**REMARKS**

Serial No. 10/730,101  
OKI.630  
Amendment dated December 29, 2004

## ANNOTATED SHEET

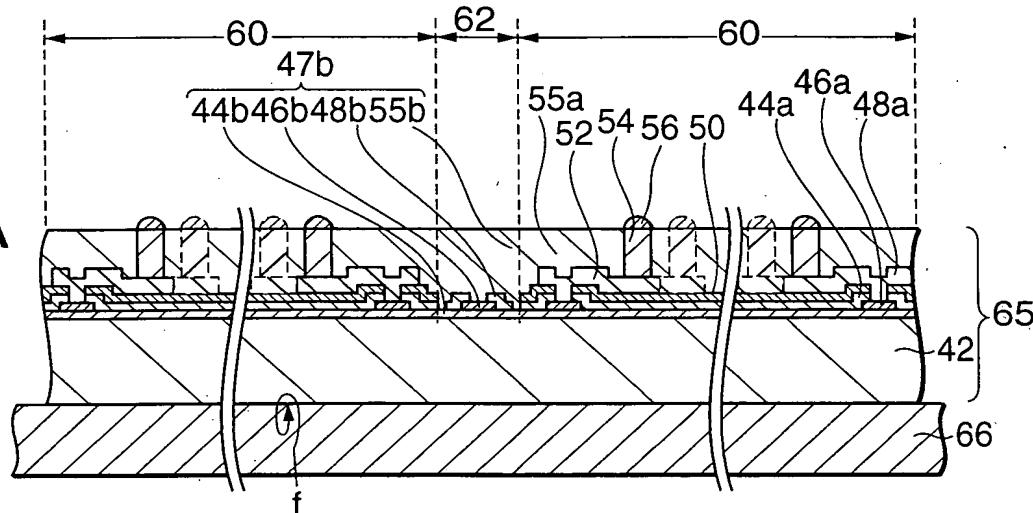
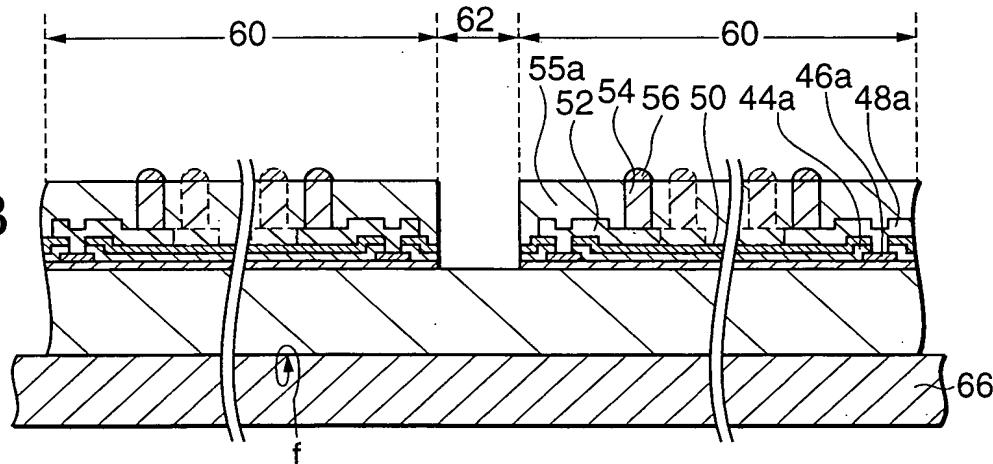
Enclosed is one (1) red-inked Drawing Annotated Sheet, wherein the dicing tape has been denoted as "66", to improve consistency. Also enclosed is one (1) Drawing Replacement Sheet, incorporating the above noted drawing correction. **The Examiner is respectfully requested to acknowledge receipt and acceptance of the Drawing Replacement Sheet.**
